CABINET MEMBER FOR ENVIRONMENT – 14 NOVEMBER 2019

BANBURY: A422 STRATFORD ROAD – PROPOSED PUFFIN CROSSING

Report for Community Operations (Interim)

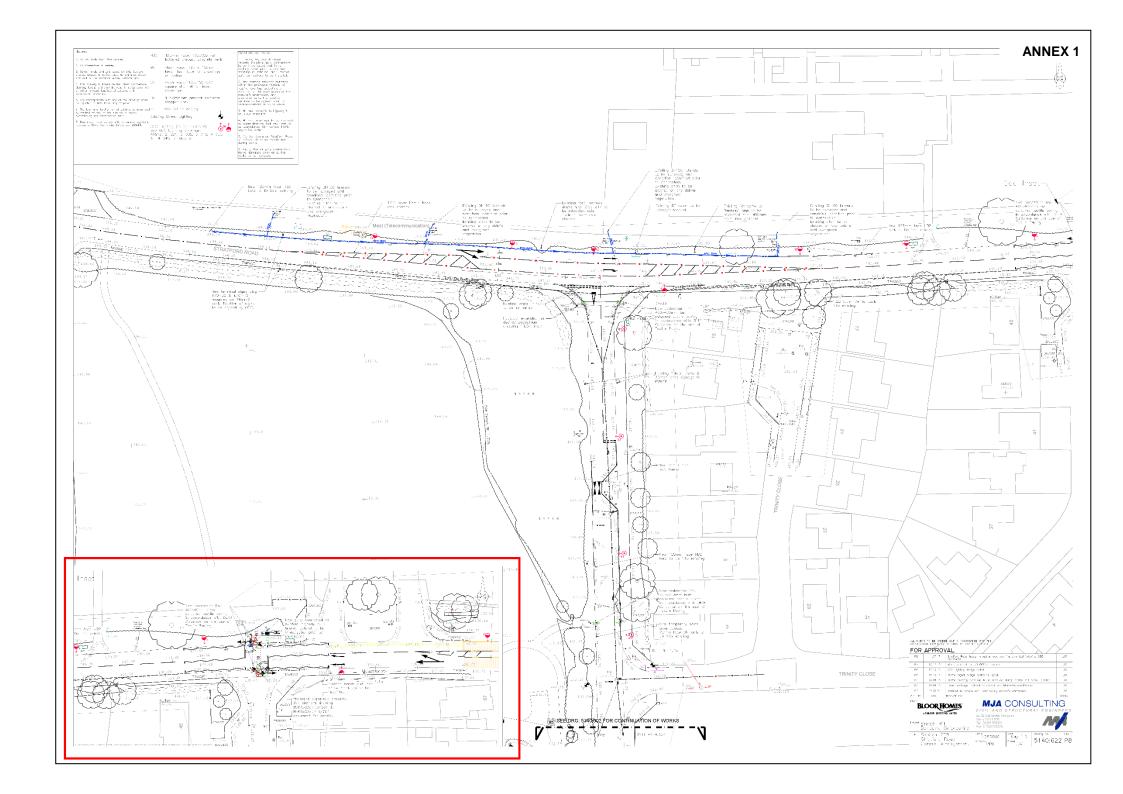
- 7. Thames Valley Police expressed no objection to the proposal but noted that the existing pedestrian refuge appeared to operate well in respect of pedestrian and driver behaviour, noting also, though, a high proportion of goods vehicles using the road.

- 10. Banbury Town Council expressed support for the scheme.
- 11. Four objections were received from local residents, citing concerns over the use of the link via Trinity Close to the Stratford Road by school students and parents parking in the close at school journey times and the resulting disturbance and problems with litter and anti-social behaviour. Their objections noted that their understanding was that a fence/hedging without a gap for pedestrians was to be provided between Trinity Close and the Stratford Road.

- 12. The above objections also expressed concerns that the consultation was being carried out after the signal equipment for the puffin crossing had been installed (but not switched on) and that the nearby zebra crossing to the east of the North Oxfordshire Academy access already provided a controlled crossing, noting the already congested conditions at peak hours.

- 15. While there is a zebra crossing approximately 90 metres to the east of the proposed crossing, in practice, pedestrians will typically not divert from their

desire line by this amount and the new crossing will be far more convenient for pedestrians approaching the North Oxfordshire Academy from the west of its access onto the Stratford Road. As with any controlled crossing traffic will be stopped when pedestrians are crossing the road but the impact on traffic movements is proportionate to the need to provide safe and convenient crossings for pedestrians, noting the importance of encouraging walking as a healthy and sustainable mode of transport.

- 13. The above responses are noted and it is accepted that it was unfortunate that the consultation was carried out after the installation works had started, though noting also that the provision of the crossing was included in the plans submitted for planning approval for the development and, therefore, had already been in the public domain.

- 14. A principal concern of those objecting appears to be a result of the pedestrian movements in particular school students between Trinity Close and Stratford Road, including also the associated parking within Trinity Close at school journey times. Although this is noted, together with the statement that such a link was not to be provided under the original plans for the Trinity Close development, this matter is beyond the scope of the current proposal.
